**CENTRAL ARKANSAS WATER  
JACK H WILSON WATER TREATMENT PLANT  
WILSON RENEWAL AND RESILIENCY PROJECT  
ADDENDUM NO. 3  
JANUARY 16, 2025**

This Addendum consists of 21 pages, including attachments.

HAZEN AND SAWYER

SODIUM HYPOCHLORITE CHEMICAL BUILDING  
ELECTRICAL  
CONTROL BLOCK DIAGRAM

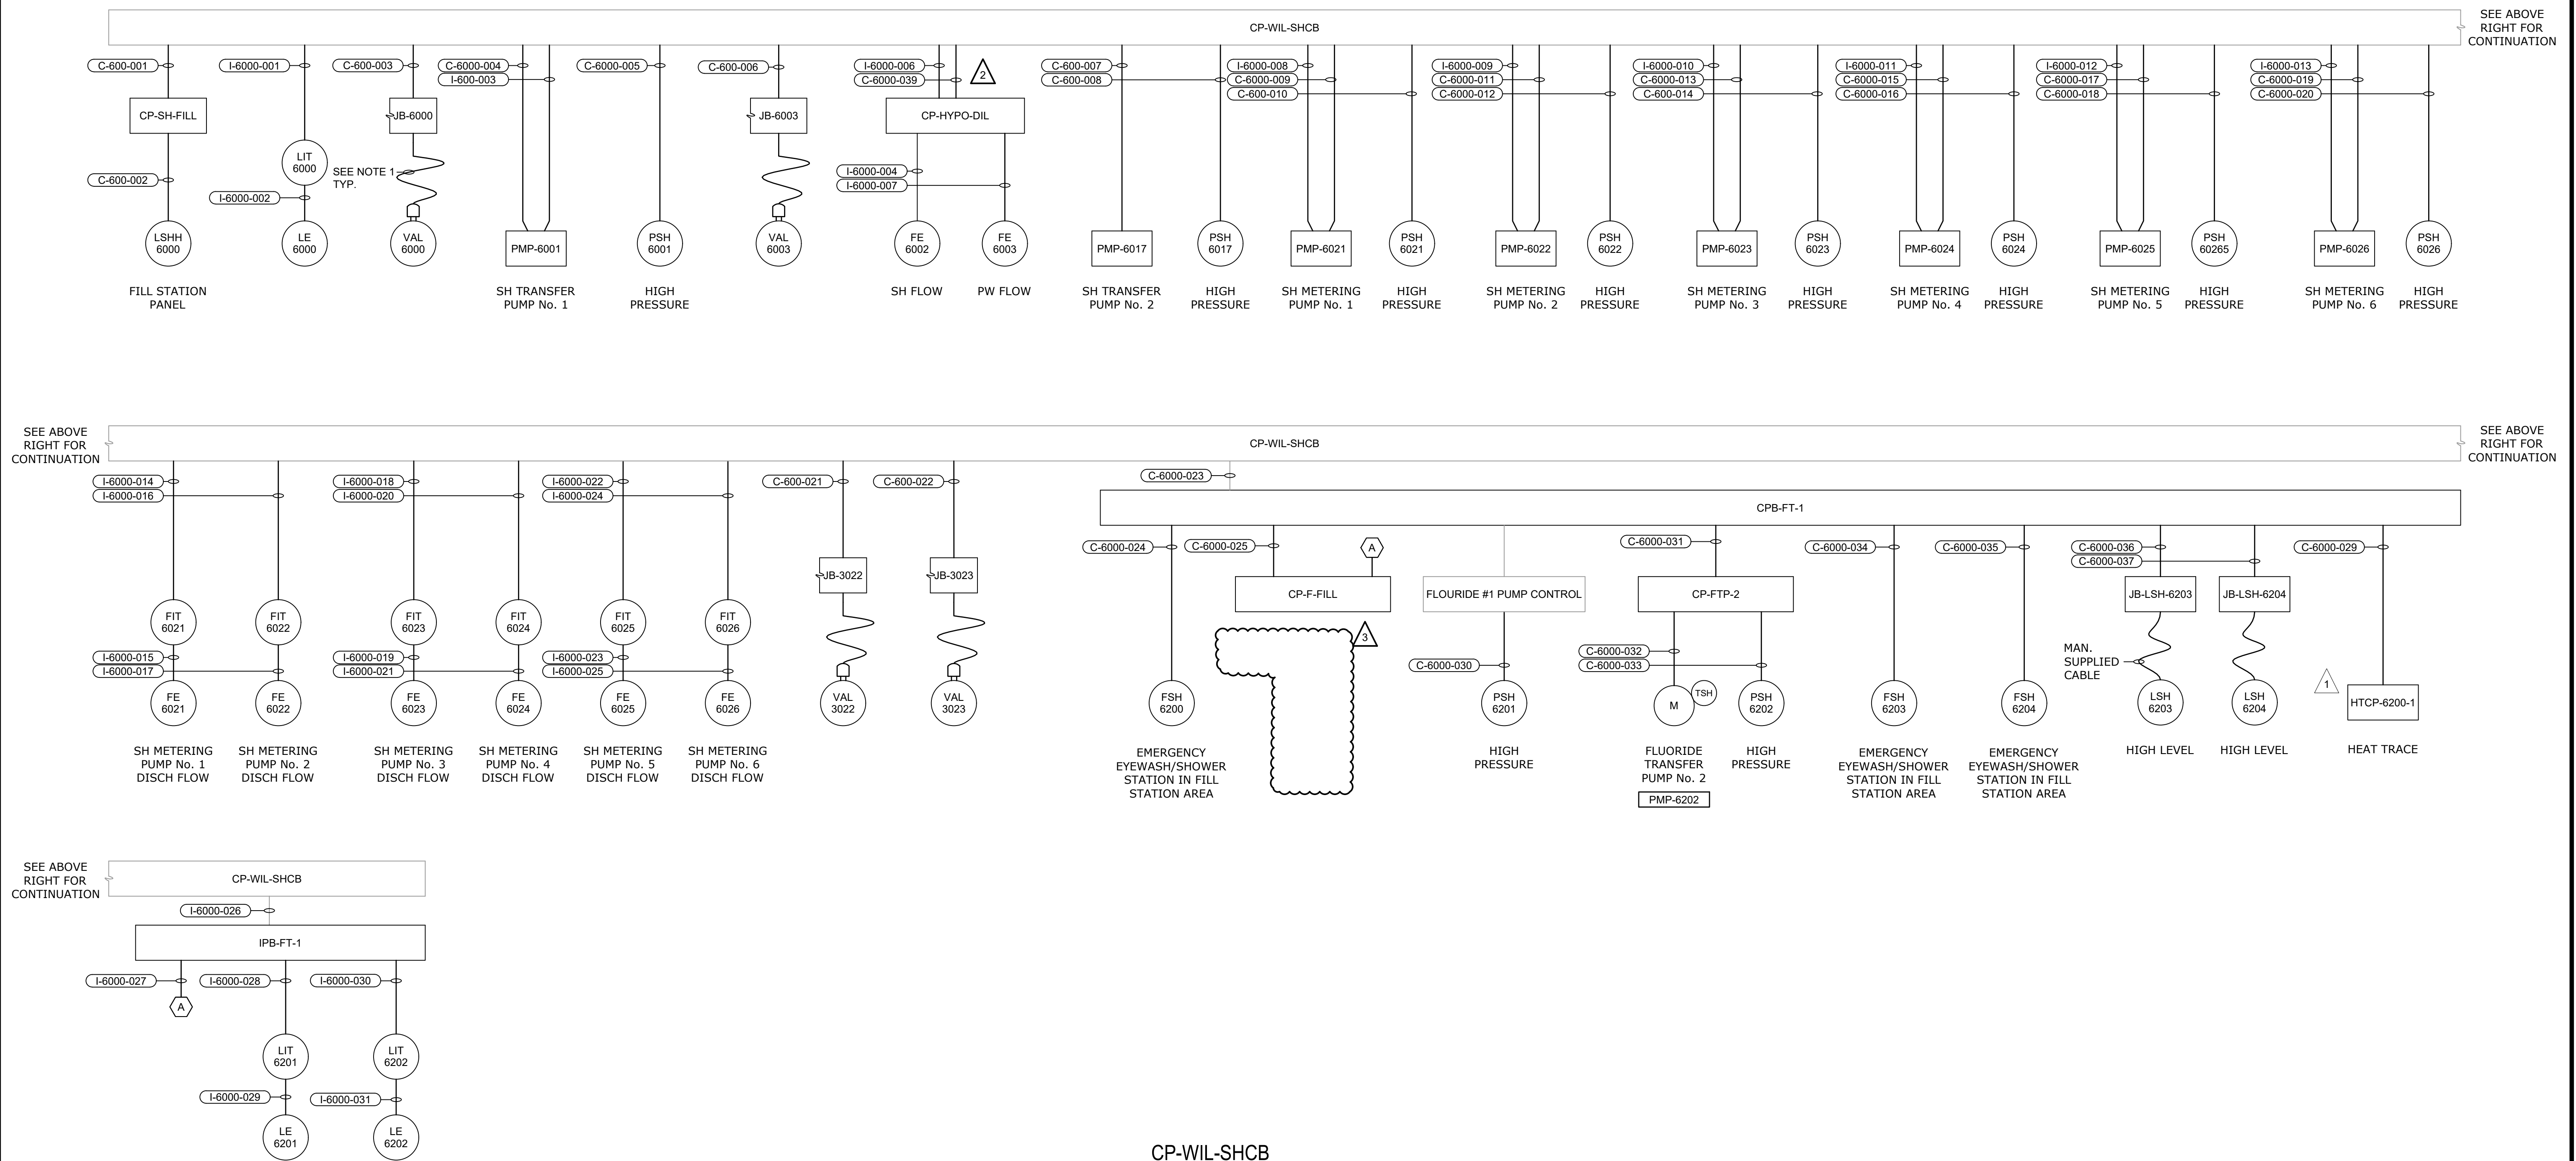
111	[Koontz Electric] The control block diagram on E6010 shows a High-High Level Switch for Tank 1 at the Fluoride Containment (LSHH-6201). The corresponding circuit is also listed on the conduit/wire schedule on E6012, C-6000-026. On the P&IDs, I6200, the only instrument shown at Tank 1 is the Radar Level LE/LIT-6201. Please confirm if LSHH-6201 should be added or not.	E6010/E6012/I6200	LSHH-6201 has been removed from Tank 1 in order to be identical to that of Tank 2.
112	[Koontz Electric] There is a control panel that shows up on the control block diagram and conduit/wire schedule for the Sodium Hypo Chemical Building as VCP-HYPO-DIL1, but on the P&IDs its labeled as CP-HYPO-DIL. Assuming this is the same panel, please confirm if this is intended to be provided as part of the vendor package as a vendor control panel or not.	E6000/I6000 series	CP-HYPO-DIL will be provided by the vendor. The Electrical drawings have been modified in Addendum No. 3 to match "CP-HYPO-DIL" as shown on the P&IDs.
